Planning and Land Use Committee Report

Subject: Development Permit Application No. 000430 for 1029 View Street

RE: **1029 View Street**
The Jukebox – Response to Application Review Summary
Victoria, B.C.

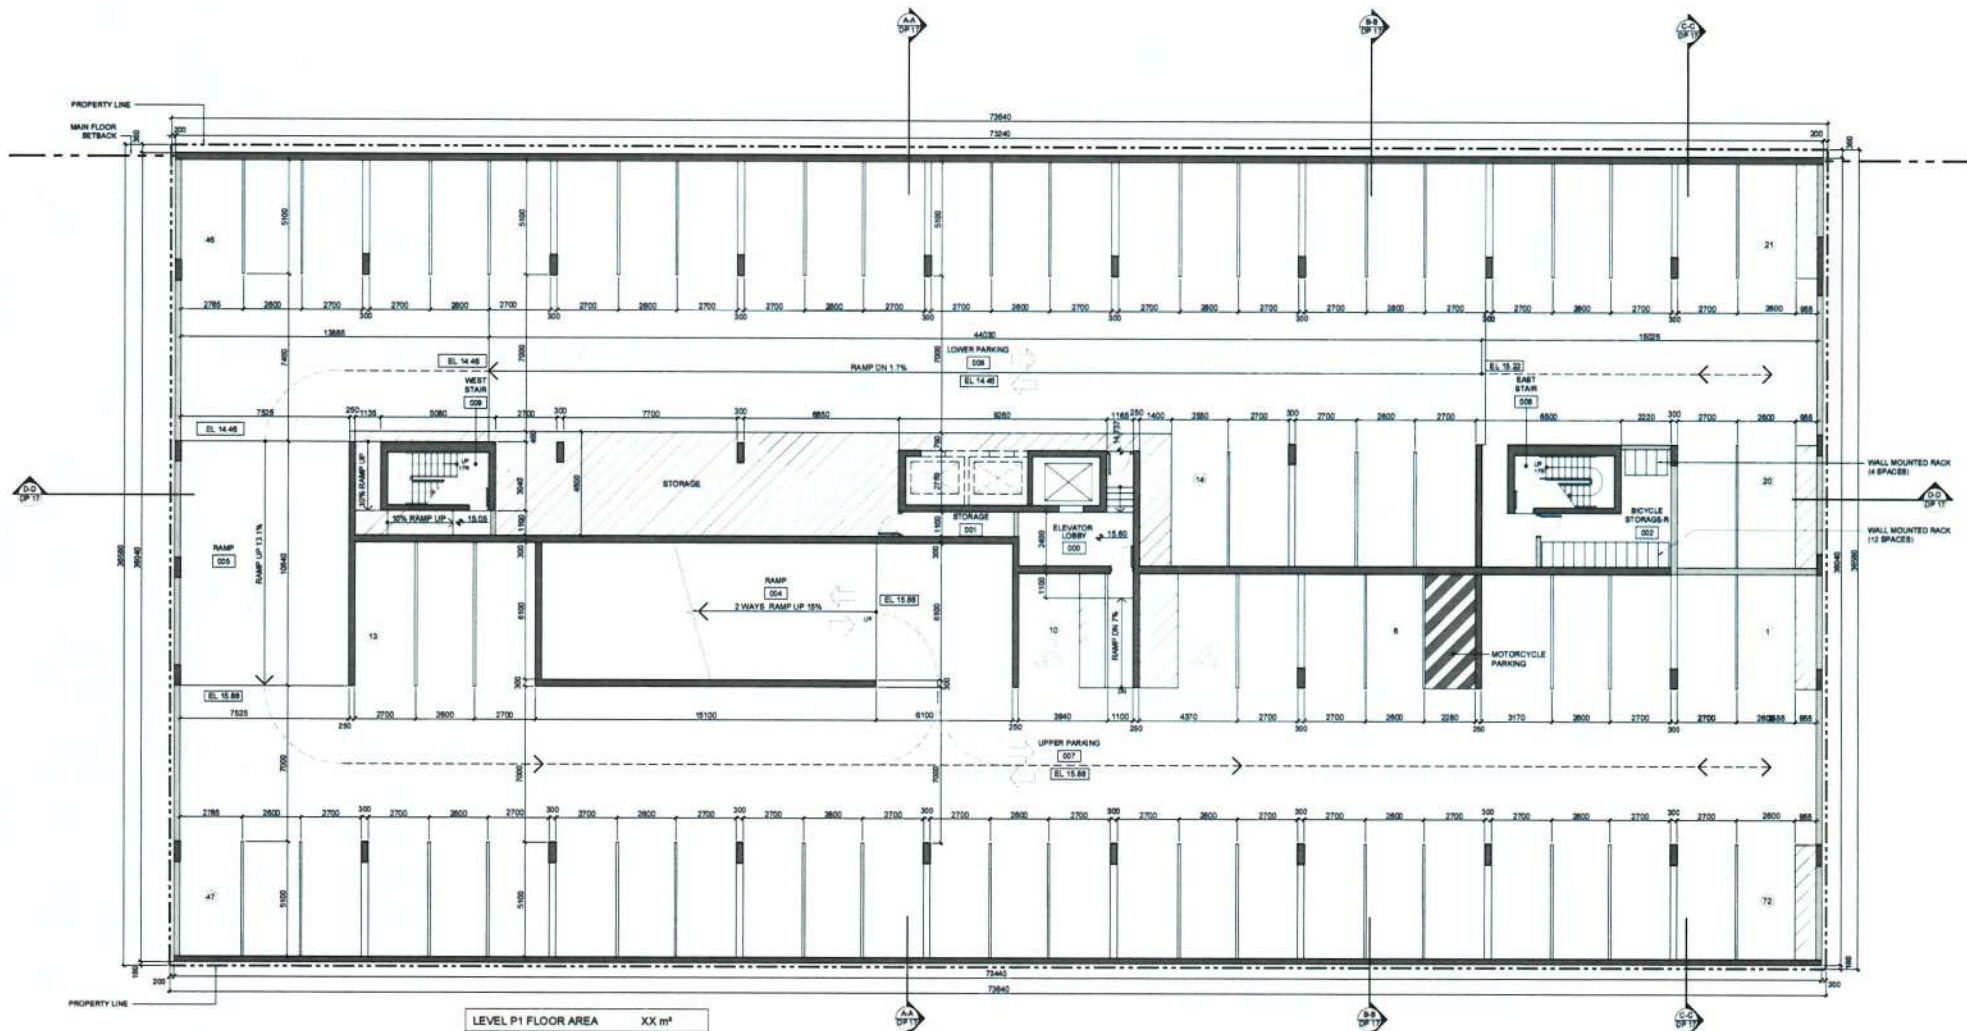
12. Our updated landscape plan shows landscaping in front of the transformer. We have provided the necessary walkway path within the landscaped area for access to the transformer. Refer to drawing L1 clouded with the number 12.

LEVEL 1 DP2

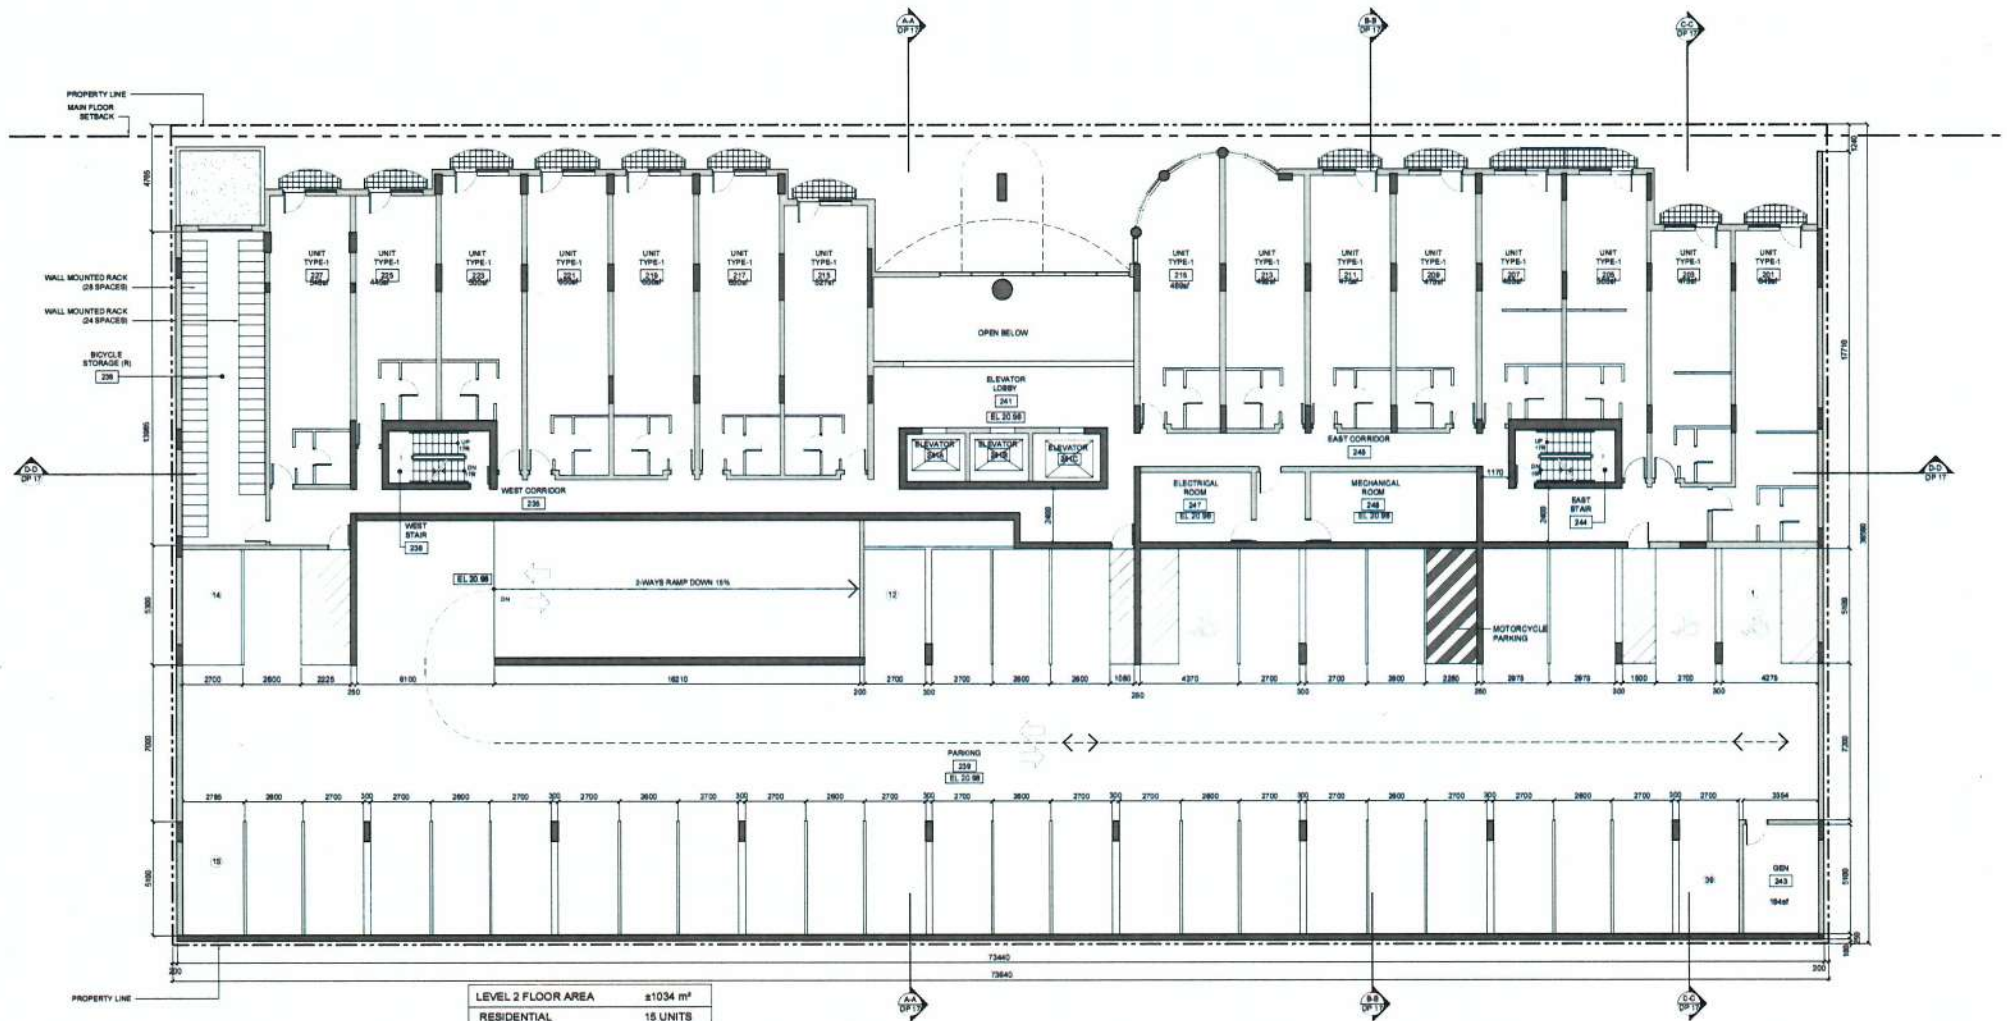
9. We have modified the CRU entry doors to incorporate more glazing. We have also added glazing at the base of the tower element (Units 107 and 109). See the attached drawings, DP2, DP3, and DP12, clouded with the number 9.

19. For the 3.0m x 3.0 m site triangle, please see updated drawings DP0 and DP2 as clouded with the number 19.
20. We can confirm that our driveway access will be no more than 5%. Refer to drawing sheets DP2 and DP17 clouded with the number 20.
21. Refer to the letter from Progressive Waste Solutions (Attachment #2) regarding how the recycling and garbage will be handled.

22. Please see updated Site Plan and Level 1 Plan indicating the driveway width. Refer to drawing sheets DP0 and DP2 clouded with the number 22.
23. This letter acknowledges that the Developer is financially responsible for the "Harris Green" sidewalk pattern across the remainder of the property. The sidewalk pattern will extend beyond into the driveway crossing. Refer to drawing sheet L1 clouded with the number 23.
24. Bike Stalls are shown on drawings DP0, DP1, DP2, and DP3 and are clouded with the number 24. There are a total of 225 bike stalls provided.
25. The Landscape Plan show on sheet L1 has been updated to coordinate with our Site Plan and Level 1 Floor Plan. Changes are clouded with the number 25.
26. We will engage an Arborist to develop a plan for the protection of the street trees during construction. The Arborist Report is not available at this time.

LEVEL 7 **DP8**

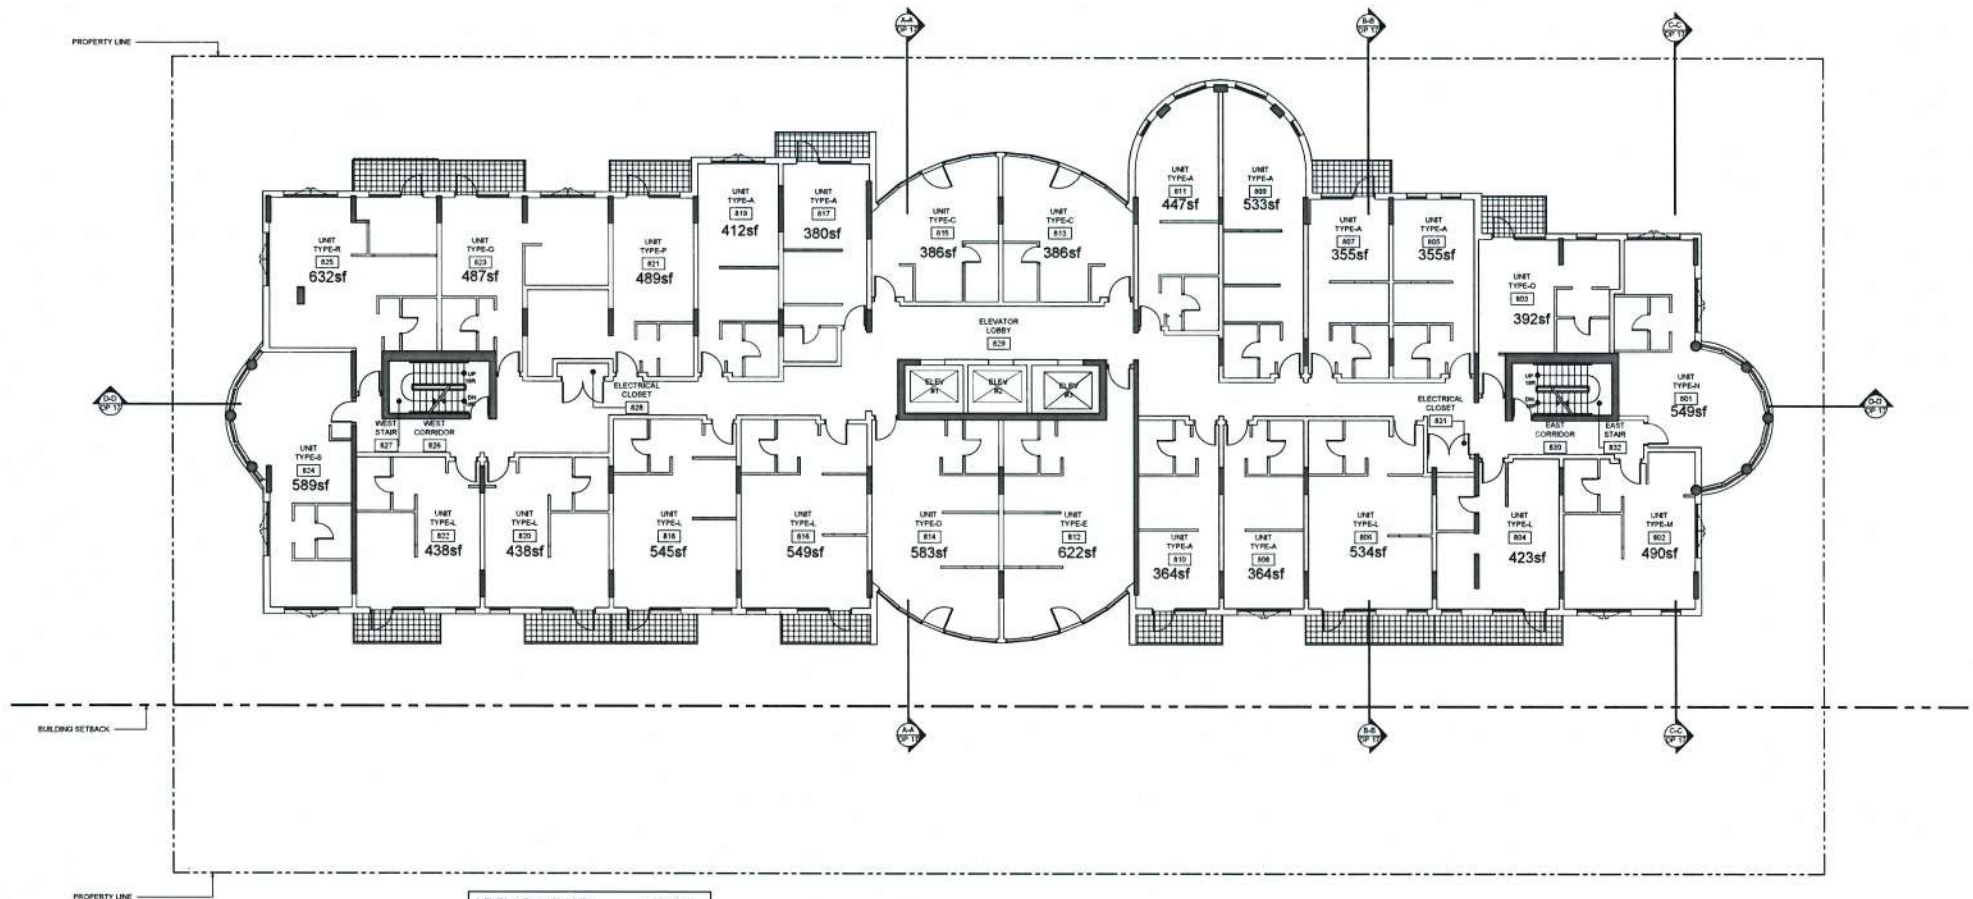
Height	Floor Plate Limitation (as described in DCAP)	Proposal
Portion of building less than 20 m	No restriction	N/A
Portion of building between 20 m and 30 m (levels 7-9)	930 m ² (10,010 ft ²)	1,073 m ² (11,550 ft ²) exceeded on levels 7-8

As noted in the table above, the proposal exceeds the maximum floor plate limitations by 143m² on levels seven and eight. Larger floor plates often accentuate the bulk of buildings. As a result, it is important that the visual impact of larger floor plates is broken down through careful design consideration and material selection. The current proposal does not include any architectural features (such as a change in material) that might help to mitigate the oversized

floor plates on levels seven and eight. Staff recommend for Council's consideration that this aspect of the proposal be reviewed by the ADP.

The Downtown Core Area Plan is concerned with the visual impact of taller bulky buildings for a more graceful skyline. To this end, Appendix 6 recommends that for portions of buildings between 20 meters to 30 meters, the residential floor plate should be restricted to 930 sq.m. As indicated in our Appendix 6 Analysis drawing, our floor plates for levels 7 and 8 are 1073 sq.m. Although the recommended floor plate size is exceeded by 143 sq.m., Gustavson Wylie Architects believes that the relatively small increase in floor plate size does not negatively impact the visual impact of the building's skyline.

The Jukebox above level 5 is extensively setback on all 4 sides, not only in plan, but also in elevation. In fact, the building can be perceived as 3 separate buildings. Referring to our rendering, since the approach to our building is oblique in nature, i.e. the approach to our entry is parallel to the street; the visual plane can be perceived to extend infinitely in both directions. Since our façade and massing is articulated, building elements can be seen from the west portion, the central portion, in the form of the curtain wall and rounded feature element; and the east portion. The articulation and perception of these 3 elements assist in reducing the bulk of the building and help reinforce the animated streetscape and circulation. Additional reduction in floor plate area may in fact have a negative impact on the overall design of our building.
